THE CITY OF SAN DIEGO

MEMORANDUM

SUBJECT: Microtrench Standard Drawing SDG 165

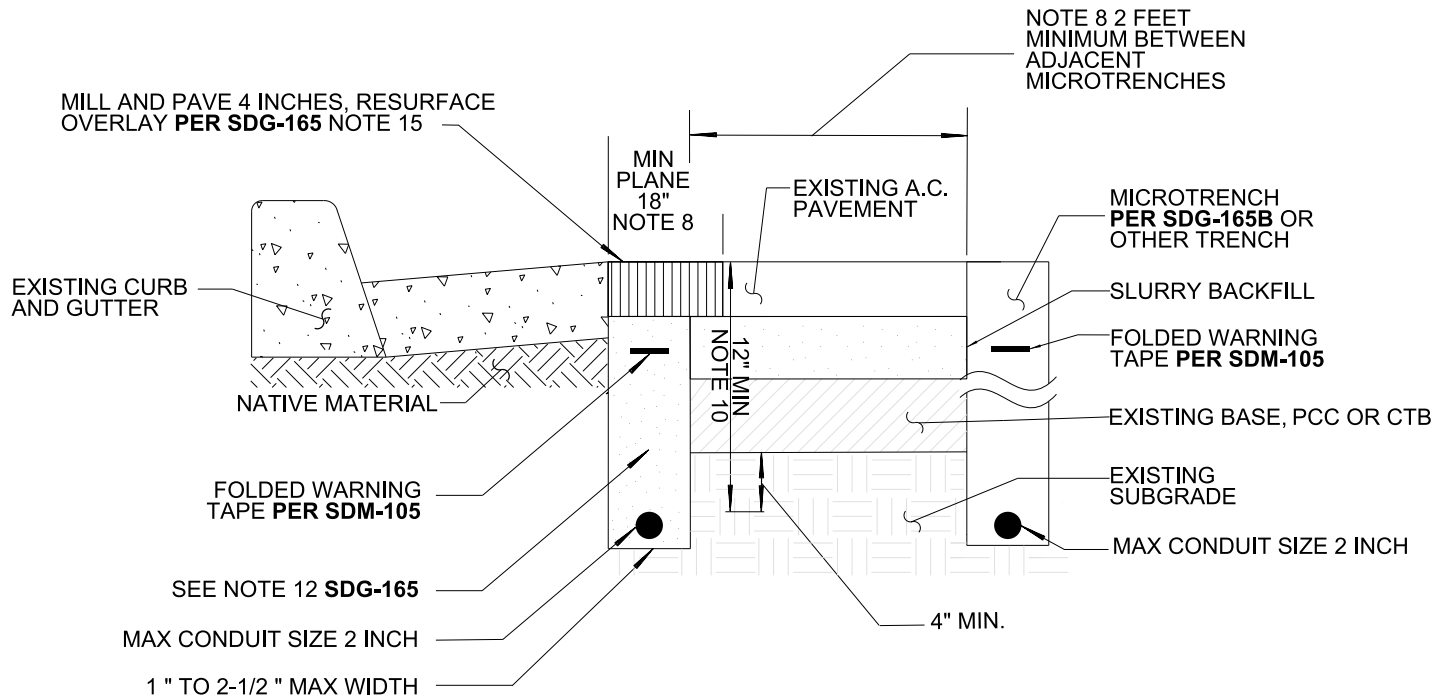
In the spirit of collaboration and as a compromise, the proposed requirement was modified from the original proposal of 6" depth below pavement section down to 4". The 4" protects a microtrench utility conduit in place and allows other contractors to investigate the subsurface utility for discovery during their work as with any other utility in the street.

9. **CONDUIT PLACEMENT IN TRENCH:** THE TOP OF HIGHEST CONDUIT SHALL BE 12 INCHES MINIMUM FROM TOP OF PAVEMENT OR 4 INCHES FROM BOTTOM OF PAVEMENT SECTION TO INCLUDE ASPHALT, BASE AND CTB, WHICHEVER IS GREATER.
